NELSON MEADOW		2 10-24-06	PER VILLAGE REVIEW
WEST SIDE OF CARPENTER STREET		11 7-21-06	PER VILLAGE REVIEW
DOWNERS GROVE, ILLINOIS		10 5-23-06	PER VILLAGE REVIEW
		9 4-05-06	PER VILLAGE REVIEW
GEOMETRIC PLAN		DRAWN BY: JWB	CHECKED BY: BLH
		SCALE: 1"=30'	DATE: 1-24-05
		JOB NUMBER: 04-239	SHEET: 7 OF 17
Consulting Civil Engineering Land Planning & Surveying			
CM C.M. Lavoie & Associates, Inc.			
#	DATE	DESCRIPTION	
1	2-16-05	PER VILLAGE & CLIENT REVIEW	
2	4-12-05	PER VILLAGE & SANITARY DISTRICT	
3	6-02-05	PER VILLAGE REVIEW	
4	7-01-05	PER VILLAGE REVIEW	
5	8-08-05	PER VILLAGE REVIEW	
6	9-15-05	PER VILLAGE REVIEW	
7	9-26-05	PER VILLAGE REVIEW	
8	12-05-05	PER VILLAGE REVIEW

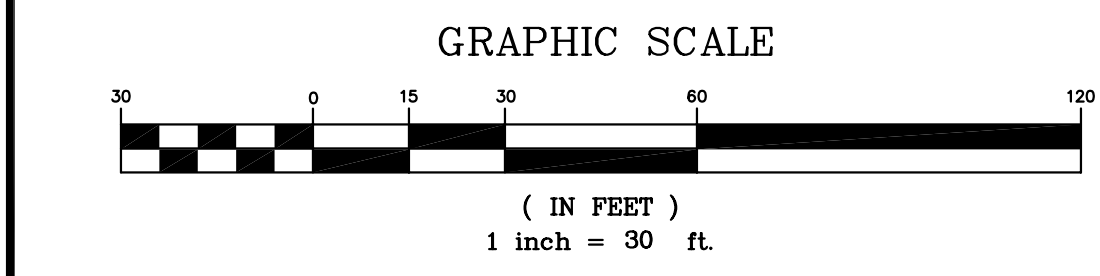
REVISD PLANS PER REVIEW LETTER FROM VILLAGE OF DOWNERS GROVE DATED JUNE 30, 2006.
 1. REVISED CROSS SECTION OF THE WALKING PATH SOUTH OF DETENTION POND.

REVISD PLANS PER INTEROFFICE CORRESPONDENCE BY PUBLIC WORKS DEPARTMENT VILLAGE OF D.G. DATED OCTOBER 27, 2005.
 1. REVISED FORM OF ROCK SWALE TO INCORPORATE CURVILINEAR FEATURES.

REVISD PLANS PER INTEROFFICE CORRESPONDENCE BY PUBLIC WORKS DEPARTMENT VILLAGE OF D.G. DATED SEPTEMBER 7, 2005.
 1. ADDED 5' WIDE LIMESTONE SIDEWALK ON SOUTH SIDE OF PROPERTY, CONNECTING JEFFERSON AVENUE TO CARPENTER STREET.

REVISD PLANS PER REVIEW LETTERS FROM VILLAGE OF D.G. JULY 5, 2005 AND FROM CBDEL DATED JULY 29, 2005.
 1. ADDED RIP-RAP SWALE IN DETENTION BASIN.
 2. REVISED RETAINING WALL TO PROVIDE A DISTANCE OF 7.50' FROM PROPERTY LINE TO WALL.

REVISD PLANS PER REVIEW LETTERS FROM VILLAGE OF D.G. MARCH 18, 2005 & D.G. SANITARY DISTRICT APRIL 4, 2005.
 1. CUT THE SOUTH CUL-DE-SAC OUT MAKING A 90 DEGREE TURN.
 2. EXTENDED PROPOSED SIDEWALK TO EXISTING SIDEWALK ON EAST JEFFERSON.
 3. EXTENDED DRIVEWAYS ON EAST JEFFERSON TO STREET.
